Neon Photography Studio Rennovation
1419 Story Ave, 40206
15COA1260

Conditions of the COA that we have had to address (up to current):

Conditions of the current COA that we are proposing amendments to:

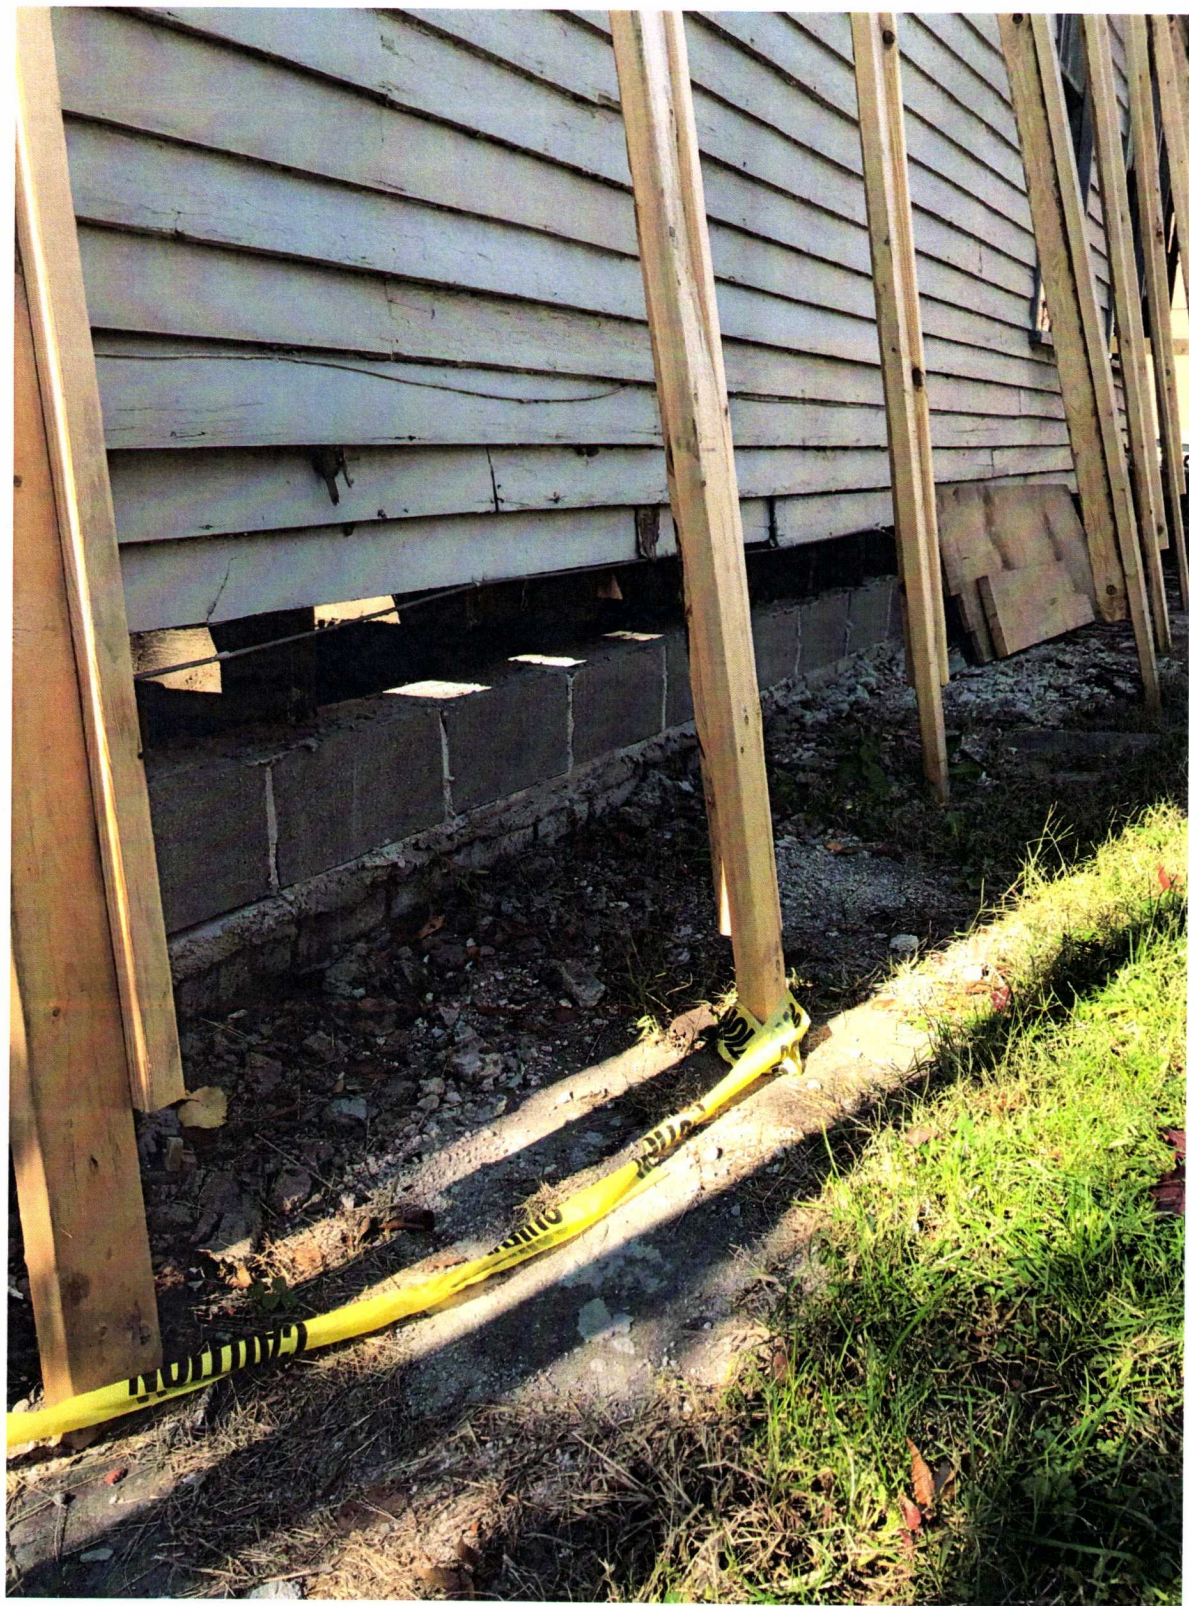
1. Metal roof on the historic and new portions of the building
 - a. This was a requirement of the original COA that we hope to be able to amend to asphalt shingle roofing. Our reasoning is two-fold. First, the original historic building had an asphalt shingle roof. Second, the unexpected costs that were incurred in relation to the front of the building has greatly affected the overall economy of the project, and owner's are hoping to recapture some of this expenditure.

2. new fiber cement siding (both horizontal lap and vertical)
 - a. original COA calls for existing wood lap siding to be repaired/replaced. Because of the circumstances and the existing historic fabric no longer exists, our hope is that we can amend the COA to allow for fiber cement siding to be used on this front shotgun section for durability and longevity. The siding will match in reveal and aesthetic of historic wood siding.
